UNITED STATES
NUCLEAR REGULATORY COMMISSION
WASHINGTON, D. C. 20555

June 4, 1979

This refers to your letter dated January 26, 1979, and March 9, 1979 requesting evaluation of your Model NMG-2 moisture gauge.

THE OHMART CORPORATION
CINCINNATI, OHIO
NMG-2 MOISTURE GAGE
OUTLINE
CINCINNATI, OHIO
1970

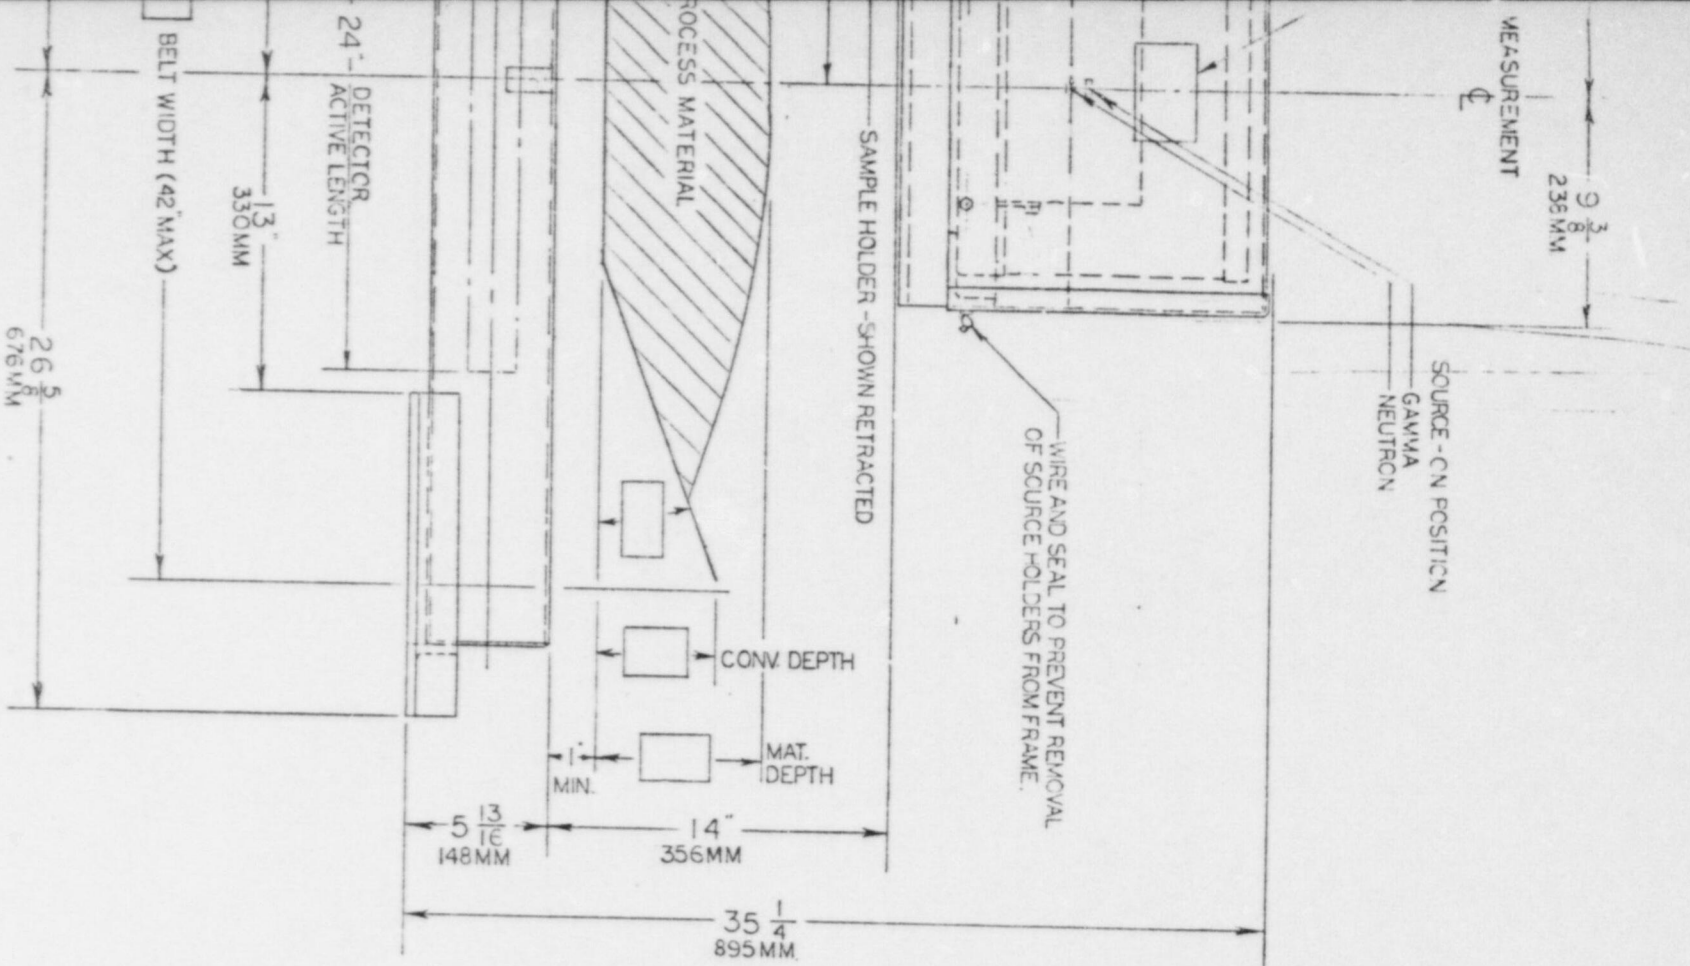
We have reviewed the design information and test data provided in your letters and find that the Model NMG-2 gauge with the Models SHN and SHWA source holders is acceptable for licensing purposes. It is our understanding that this device will use a 50 millicurie cesium-137 source and a 2.5 microgram californium-252 neutron source. The device will be distributed to specific licensees only.

Please note that a leak test frequency of at least once every six (6) months is required for the californium-252 source in this device. Prior to approval of the source for extended leak test periods, we need test data which verifies that the californium-252 sealed source, used in the Model NMG-2 gauge under operational conditions, has not leaked radioactive material in excess of 0.005 microcuries over a three year period. (Leak test should be taken at six (6) month intervals on a sufficient number of sources to insure statistical reliability).
